DESCRIPTIVE REPORT

Type of Survey Side Scan Sonar

Registry No. H10863

Locality Drum Island To Daniel Island Bend

Section from Chart 11524
42nd edition, Nov. 9/96

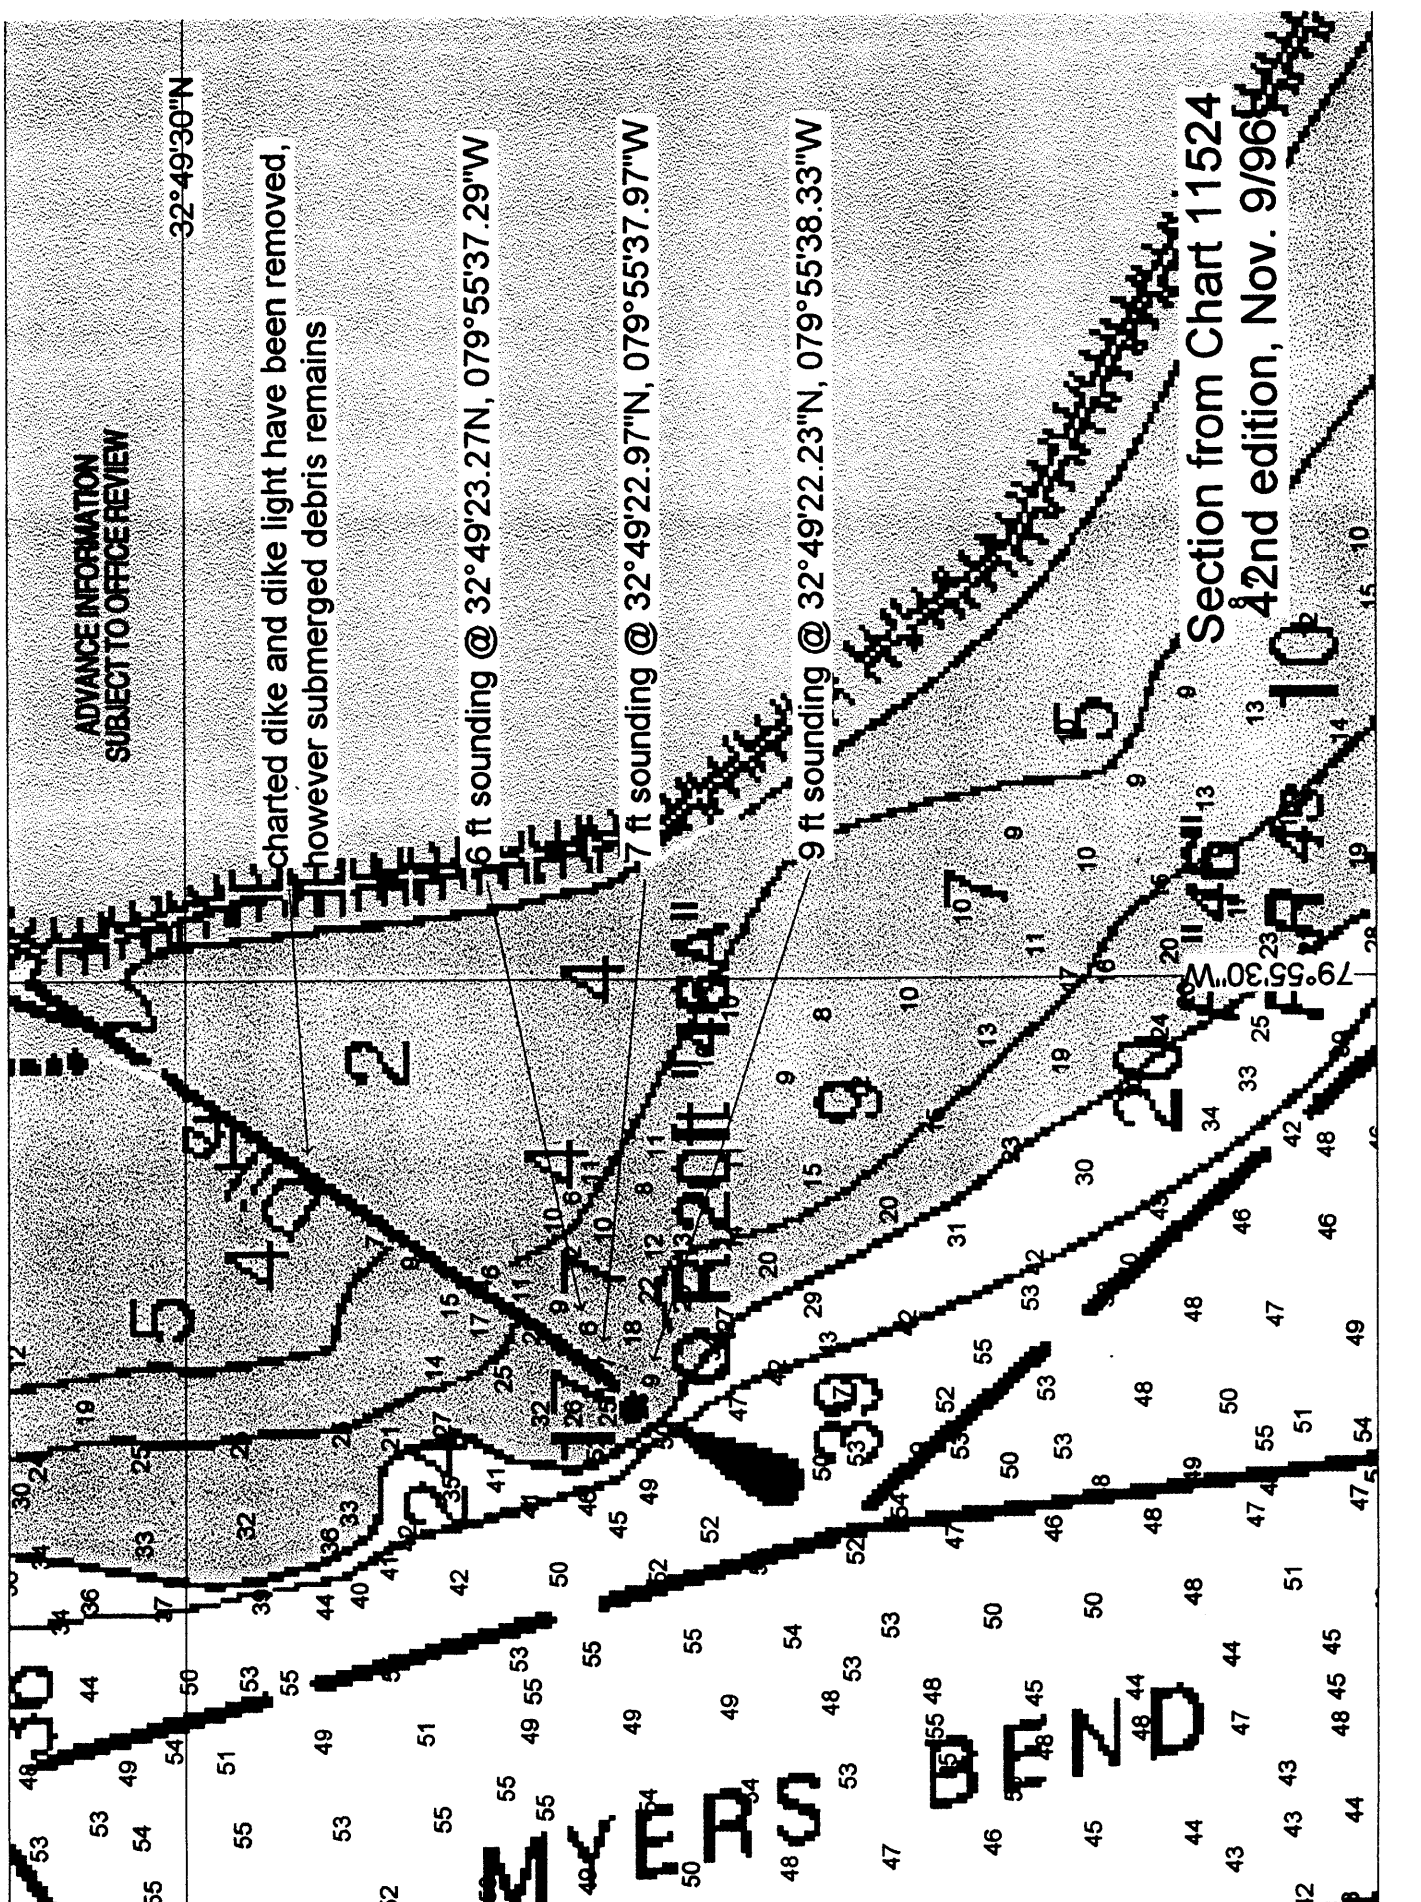
charted dike and dike light have been removed,
however submerged debris remains

6 ft sounding @ 32°49'23.27"N, 079°55'37.29"W

7 ft sounding @ 32°49'22.97"N, 079°55'37.97"W

9 ft sounding @ 32°49'22.23"N, 079°55'38.33"W
